SUBJECT: PRAIRIE ISLAND NUCLEAR GENERATING PLANT, UNITS 1 AND 2 -
ISSUANCE OF AMENDMENT REVISING SPENT FUEL POOL CRITICALITY
TECHNICAL SPECIFICATION (CAC NOS. MF7121 AND MF7122, EPID L-2015-
LLA-0002)

SAFETY EVALUATION BY THE OFFICE OF NUCLEAR REACTOR REGULATION

PRAIRIE ISLAND NUCLEAR GENERATING PLANT, UNITS 1 AND 2

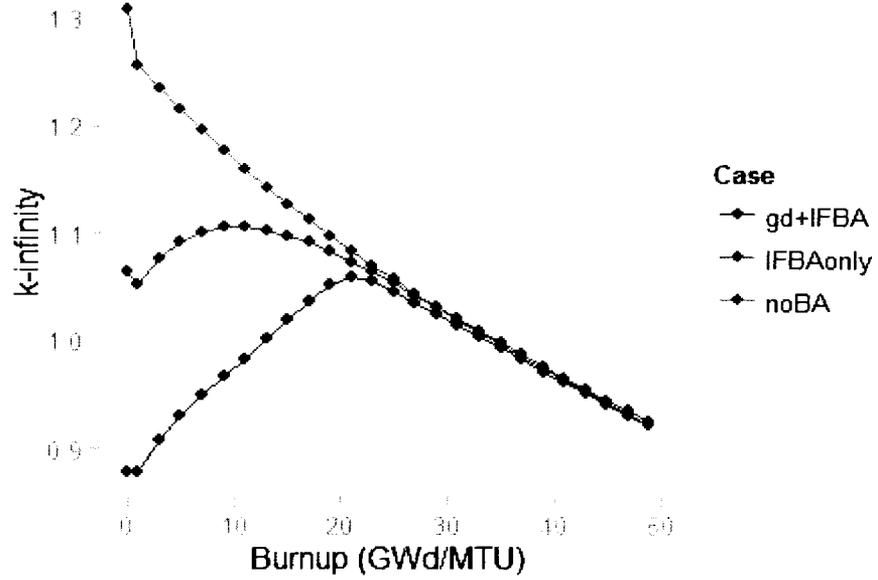
In WCAP-17400, S1, R2, integral fuel burnable absorber (IFBA) was added as a fuel assembly burnable absorber (BA), in separate fuel pins, in addition to Gd. The U.S. Nuclear Regulatory Commission (NRC) performed three separate fuel assembly depletion calculations to confirm the licensee's claim that only modeling IFBA, and continuing to not model Gd, is a conservative practice for the proposed Prairie Island Nuclear Generating Plant (PINGP) fuel design. The three calculations assume:

- [[]] IFBA fuel rods; [[]]
 - Concentration: [[]] mg/in; [[]]
 - Thickness: [[]] mils; [[]]
 - Length: [[]] in; not considered in 2D depletion calculation
- [[]] Gd fuel rods at a concentration of [[]] Gd; [[]] Gd rods modeled; 1 Gd ring
- Burnable absorber map assumed since not provided by Westinghouse:
 - 1 represents fuel rod without BA
 - 2 represents GT
 - 3 represents IT
 - 4 represents fuel rod with only IFBA as BA
 - 5 represents fuel rod with only Gd as BA

Comparison of k-effective versus burnup for the three cases confirms the WCAP-17400, S1, R2, conclusion that continuing to not model Gd, while modeling IFBA, will result in a conservative set of spent fuel isotopics to be used in the PINGP SFP CSA. In the figure below, it is seen that modeling no burnable absorber will result in a conservative set of isotopics up to a burnup of approximately 30 GWd/MTU. After this burnup, it is more conservative to model only IFBA with no Gd. However, either of these cases bounds the actual case where both IFBA and Gd are present for all burnup. Consequently, the IFBA only burnable absorber assumption is acceptable to use for the proposed PINGP fuel design which now includes IFBA.
